# Historic Preservation Commission

March 12, 2020

Certificate of Appropriateness

**1610 3<sup>rd</sup> Avenue SE**

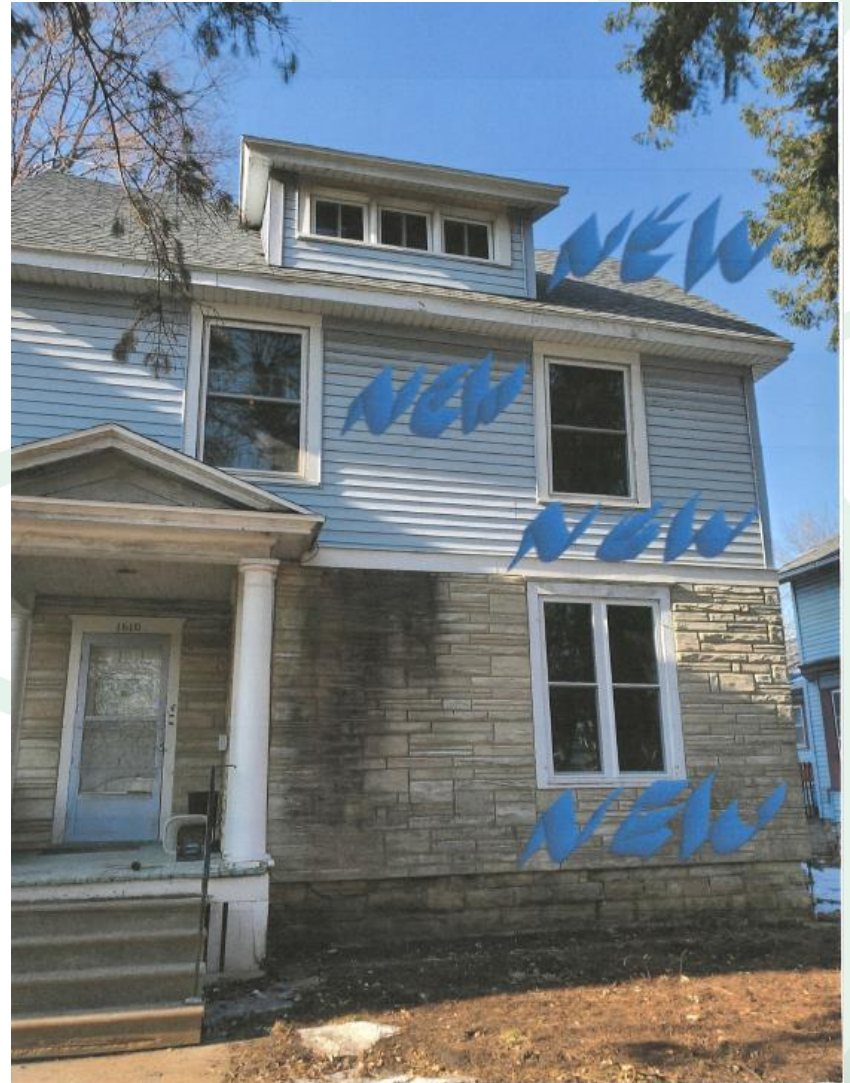
- Primary structure built in 1900
- The applicant installed 27 vinyl windows under the assumption a permit was already granted for a previous contractor
- House contributes to the 2<sup>nd</sup> & 3<sup>rd</sup> Avenue Historic District, but is not individually eligible

- Aluminum siding was installed on top portion of the house
- Windows were wrapped in aluminum
- 2 windows were replaced with vinyl windows before this project

- Action approved at 2/27 meeting:
  - **Front:** HPC recommended the applicant replace the front windows with wood in the same style that was previously there
  - **West:** Approved COA for vinyl windows on the west side
  - **East:** Recommended the applicant replace the 1<sup>st</sup> floor windows on the east side with wood windows. 2<sup>nd</sup> floor windows could remain vinyl
  - **Back:** Approved the COA to keep vinyl windows on the back of the house
